HISTORIC AND DESIGN REVIEW COMMISSION

July 07, 2021

HDRC CASE NO: 2021-315
ADDRESS: 103 E HUISACHE AVE
LEGAL DESCRIPTION: NCB 1702 BLK 6 LOT 16 & 17
ZONING: R-4,H
CITY COUNCIL DIST.: 1
DISTRICT: Monte Vista Historic District
APPLICANT: Joseph Cotton
OWNER: Joseph Cotton
TYPE OF WORK: Construction of a second story addition on rear accessory structure
APPLICATION RECEIVED: June 07, 2021
60-DAY REVIEW: Not applicable due to City Council Emergency Orders
CASE MANAGER: Stephanie Phillips
REQUEST:

The applicant is requesting a Certificate of Appropriateness to construct a second story on the rear garage structure.

1 GUEST HOUSE SOUTH
Scale: 1/8" = 1'-0"

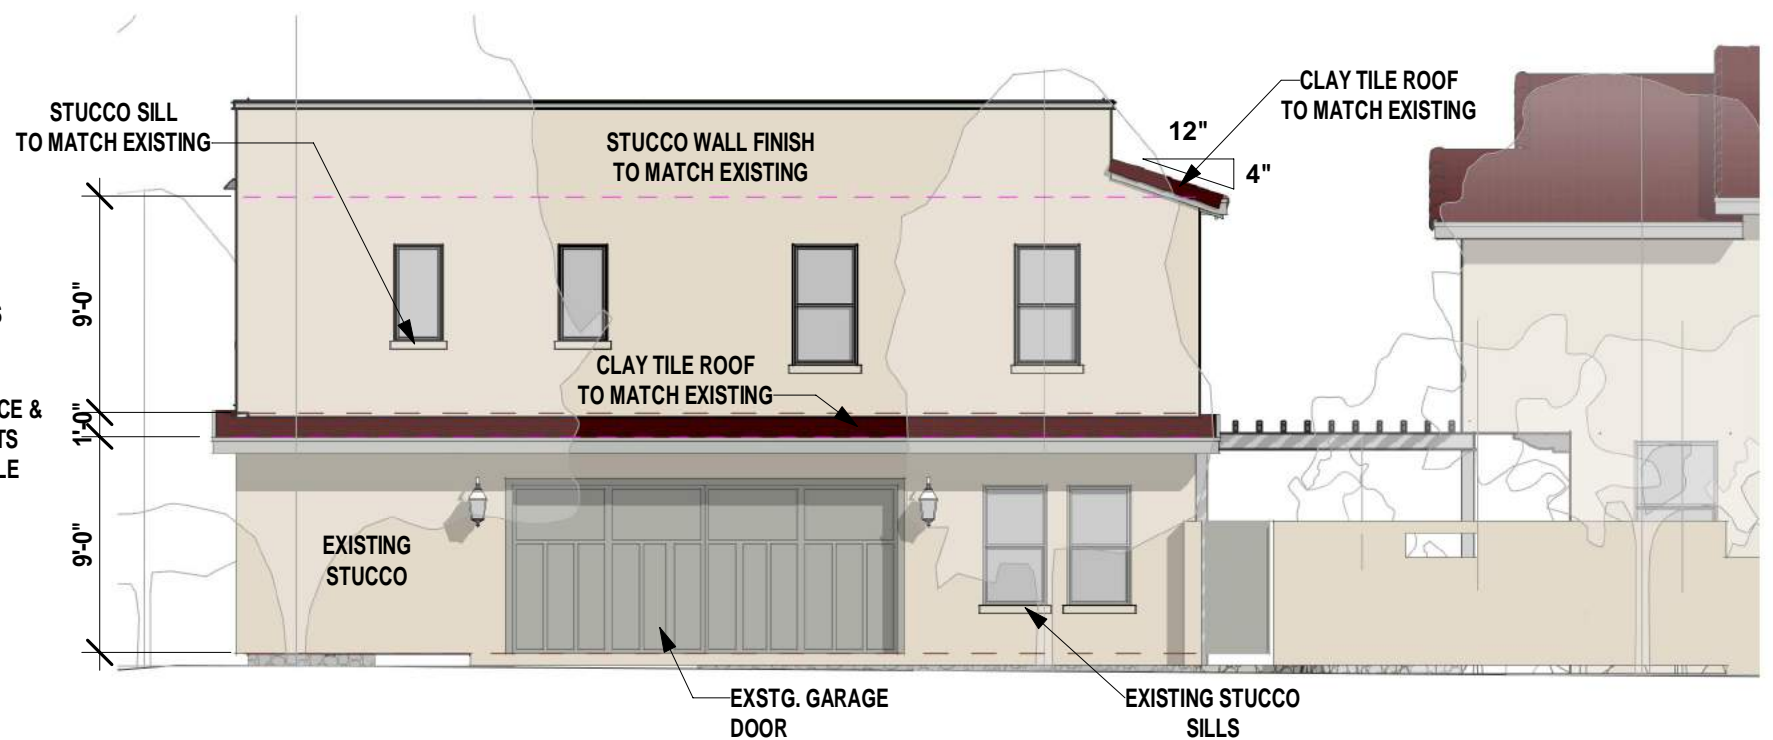
- e. **ROOF FORM** - The existing roofline of the one-story garage is flat. Per the applicant, the design keeps the new proposed height at a minimum, with a low profile, flat roof to match the existing single-story structure. The design includes point of interest with the addition of clay tile roofing at the approximate location of the existing 1-story roofline in lieu of a plain stucco finished wall that spans two stories tall. According to the Guidelines for Additions 1.A.ii., similar roof forms, pitches, and overhangs should be used on additions. Staff finds the proposed roof form consistent with the Guidelines.

- f. **WINDOWS AND DOORS** – The proposed addition includes wood one over one windows with same profile as existing on the accessory, as well as two single lite, smaller windows, on the primary façade facing N Main. The interior elevations feature a combination of one over one windows and doors. According to the Guidelines for New Construction 2.C.i, window and door openings should have a similar proportion of wall to window space as typical with nearby historic facades. Staff finds the proposed one over one windows consistent with the Guidelines, but finds that the single lite windows facing N Main should be modified to feature a one over one configuration and a size and proportion that is consistent with the fenestration pattern that exists on the primary and accessory structure.

- g. **ARCHITECTURAL DETAILS** – The addition features a second story interior balcony with a wrought iron railing, a flat and clay tile roof, and stucco finish. According to the Guidelines for Additions 4.A.ii., the addition should incorporate architectural details that are in keeping with the style of the original structure. Staff finds the proposal generally consistent with the Guidelines.

- i. That the applicant submits a detailed specification for all proposed new windows on the additions. All new windows must meet the following stipulations: windows must be fully wood windows and feature a one over one configuration as noted in finding f. Meeting rails must be no taller than 1.25” and stiles no wider than 2.25”. There should be a minimum of two inches in depth between the front face of the window trim and the front face of the top window sash. This must be accomplished by recessing the window sufficiently within the opening or with the installation of additional window trim to add thickness. Window trim must feature traditional dimensions and an architecturally appropriate sill detail. Window track components must be painted to match the window trim or concealed by a wood window screen set within the opening. The applicant is required to submit a detailed drawing and specification for the new front window to staff prior to the issuance of a Certificate of Appropriateness.

- ii. That the applicant submits material specifications for the clay tile roof and the stucco finish pattern to staff for review and approval prior to the issuance of a Certificate of Appropriateness.

- iii. That the applicant submits detailed measured drawings of the proposed brackets and railing elements to staff for review and approval prior to the issuance of a Certificate of Appropriateness.

1 GUEST HOUSE 1ST FLOOR PLAN
Scale: 1/8" = 1'-0"

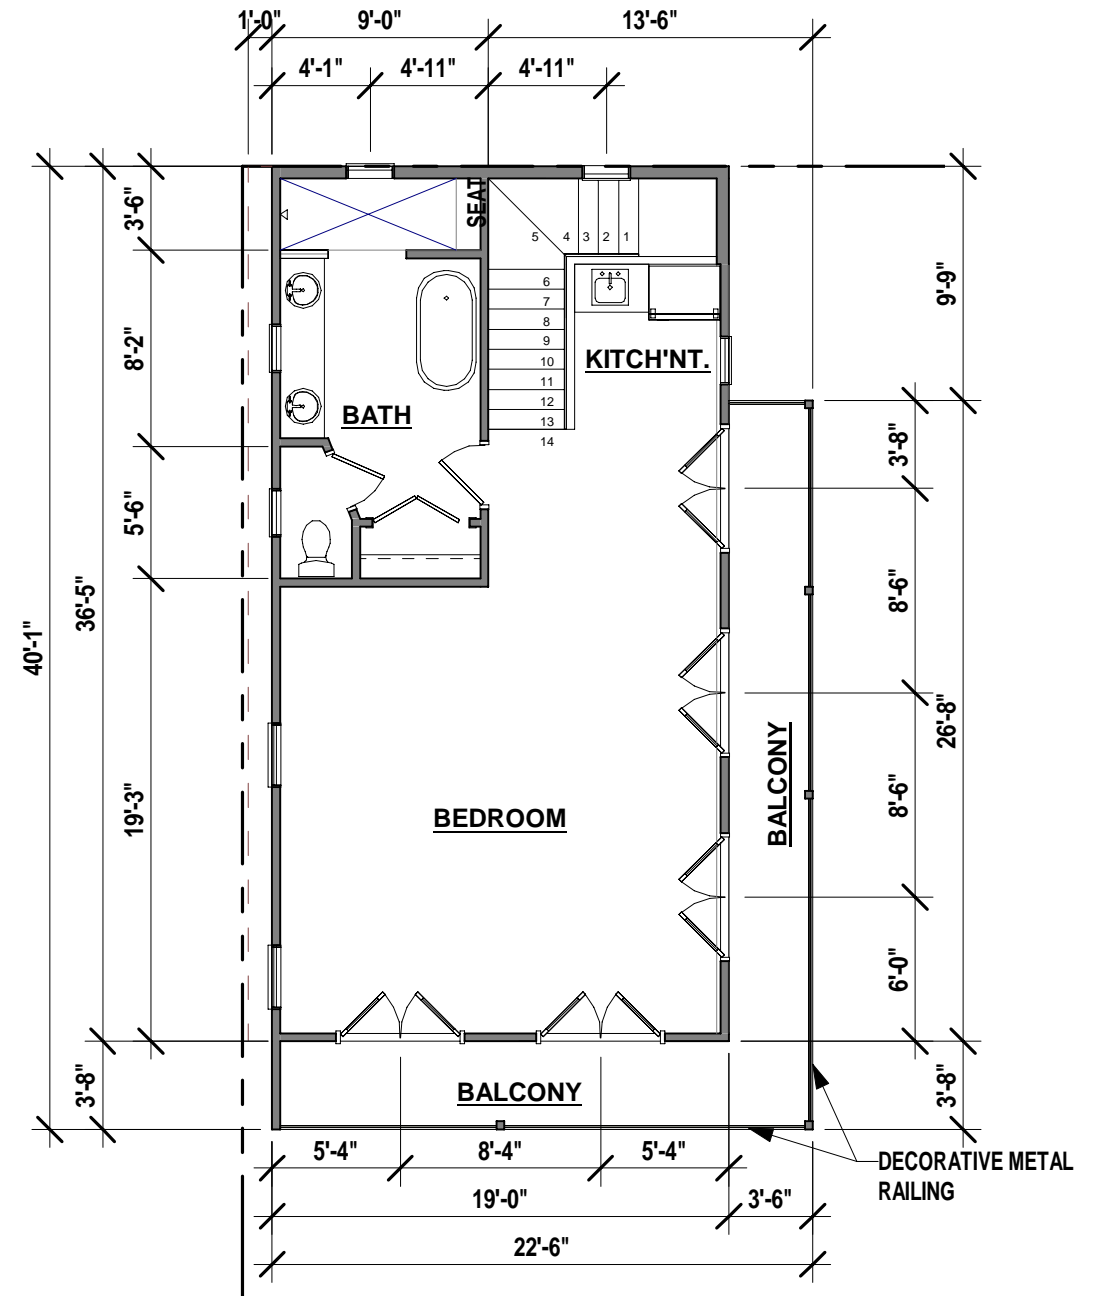
- d. **SCALE AND MASS** – The existing garage structure is 1-story and is approximately 680 square feet. The proposed addition creates a 2-story structure with a smaller footprint than the existing structure. According to

the Guidelines for Additions 1.B.i, additions should be designed to be visually subordinate to the principal structure in terms of their height, massing, and form. Staff finds that the addition does not overwhelm or visually compete with the main structure and is consistent with existing accessory structure heights in the vicinity. The Guidelines for Additions stipulate that an addition's footprint should not double that of the existing structure. Staff finds the scale and mass consistent with the Guidelines.
